# Access Compliance Report

## Public Rights-of-Way

Intersection ID: 45063	Main Street: ESCAFLOWNE_AV	Cross Street: REDDING_GLEN_AV	Location: NW
ADA ID: 4E31AE56E4AC	Ramp Type: BlendTrans1	Initial Pass/Fail: Fail	Overall Compliance: No
		Severity Score: 10

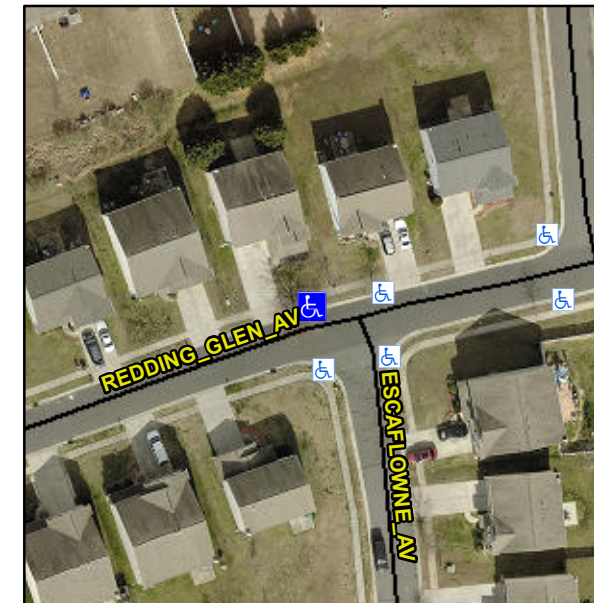
Compliance	Description	Data	Compliance	Description	Data
N/A	Ramp Length (in)	46.0	Yes	BlendTrans Slope (%)	4.5
No	Ramp Width (in)	47.0	Yes	BlendTrans XSlope (%)	2.4
N/A	Flare Type LT	N/A	N/A	Flare Type RT	N/A
N/A	Flare Slope LT (%)	N/A	N/A	Flare Slope RT (%)	N/A
N/A	Flare Traversable LT?	N/A	N/A	Flare Traversable RT?	N/A
N/A	Landing Length (in)	N/A	N/A	DWS Provided?	N/A
N/A	Landing Width (in)	N/A	N/A	DWS Contrast?	N/A
N/A	Landing Slope (%)	N/A	N/A	DWS Length (in)	N/A
N/A	Landing X Slope (%)	N/A	N/A	DWS Full Width?	N/A
N/A	Landing Curb? (Y/N)	N/A	N/A	DWS Offset (in)	N/A
N/A	Shared Landing?	N/A			
N/A	Gutter Ponding?	N/A	N/A	Gutter Slope (%)	N/A
N/A	Gutter Lip Ht (in)	N/A	N/A	Gutter X Slope (%)	N/A
N/A	Painted X Walk1?	No	N/A	Painted X Walk2?	N/A
	X Walk 1 Direction	To S		X Walk 2 Direction	N/A
	X Walk 1 Width (in)	N/A		X Walk 2 Width (in)	N/A
	X Walk 1 Slope (%)	5.5		X Walk 2 Slope (%)	N/A
	X Walk 1 X Slope (%)	4.5		X Walk 2 X Slope (%)	N/A

N/A	Ramp inside XWalk1?	N/A	N/A	Ramp inside XWalk2?	N/A
	Road Slope (%)	4.5		Clear Space?	N/A
	Road X Slope (%)	5.5	N/A	Clear Space to XWalk (in)	N/A
N/A	Any Obstructions?	N/A	N/A	Storm Grate/Utility Hazard?	N/A
	Obstruction Type			Storm Grate/Utility Type	
		N/A			N/A
			Yes	Surface Condition? (G/P)	Good
			N/A	Curb Slope (%)	4.5

**Remove & Replace Curb Ramp With Two New Directional Ramps or Equivalent.**

**R304.5.1**
